Our Ref: ABP-301908-18

Re: Greater Dublin Drainage Project consisting of a new wastewater treatment plant, sludge hub centre, orbital sewer, outfall pipeline and regional biosolids storage facility
Townlands of Clonshagh, Dubber and Newtown, County Fingal and Dublin City

REF: Greater Dublin Drainage Project **Case reference: PL06F.301908**

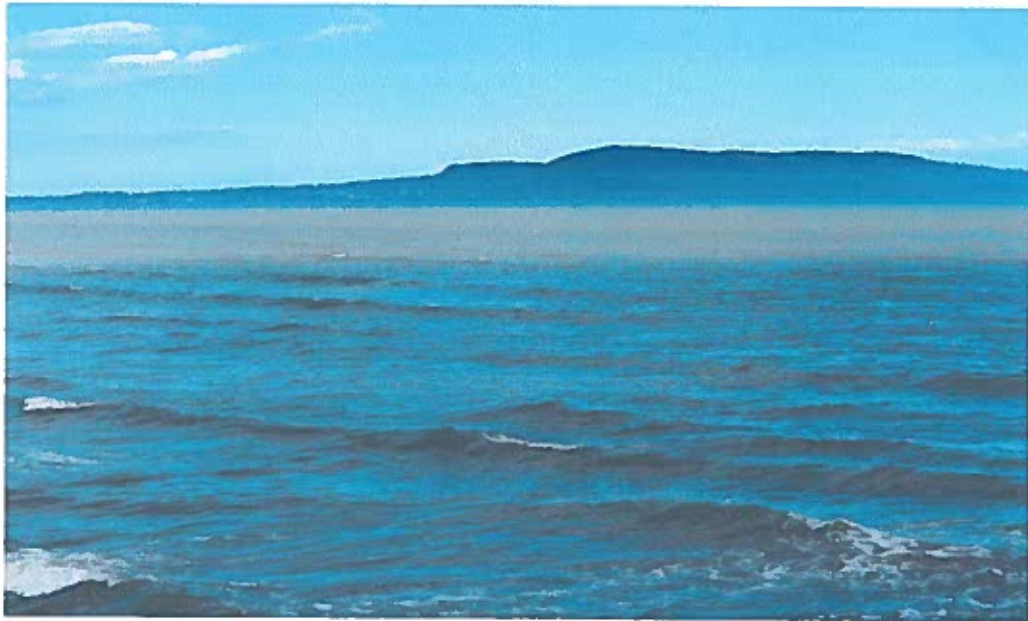
- 2-1 Storage pre-treatment: There is way insufficient early storage capacity designed to cater for "shock "loads arriving at the plant and causing untreated sewage being flushed out to sea.

- 2-2 Sea outfall: No details are given as to how they propose to dispose of the excavated materials from the micro tunnelled section of the outfall from chainage 0,0m to 2000m. No details of storage (pre-disposal) of this material at either end of the shaft are given. How do they propose to prevent leeching from these spoil heaps?

- 2-3 Micro tunnel: Its stated that the micro tunnelling will not be disruptive to wild life but they manage to omit details of the traffic of materials and staff to the shafts, craneage lowering down materials, Bentonite, pipes and removing excavated material. Trucks drawing away the excavation about 6,283 cm that is about 1200 truckloads. The micro tunnel is a major operation of one-year duration. This area is so important that it is covered by Baldoyle SPA, Baldoyle SAC and Irelands Eye SAC with another 6 European sites within a few Kilometres. They have not considered in any detail the amount of heavy duty work involved here.

- 2-4 The Sea outfall 4 Kilometres long: The proposed outfall pipe is to be buried into a trench which it is planned to be excavated out from the beach at Portmarnock out to within 1 Km of Irelands eye. The trench to be 5 Mt deep and with sloping sides, probably an average width of 7m and a length of 4,000m. The volume of material to be excavated is 140,000 cm with a weight of around quarter of a million tons. The following is omitted from the documents, all sea bed marine life for the extent of that excavation will be wiped out/killed during the excavation works. The excavated material will be excavated out onto a barge only later to be dropped back down through the water column adjacent to the pipe trench. All marine life under the dropped material will be wiped out also.
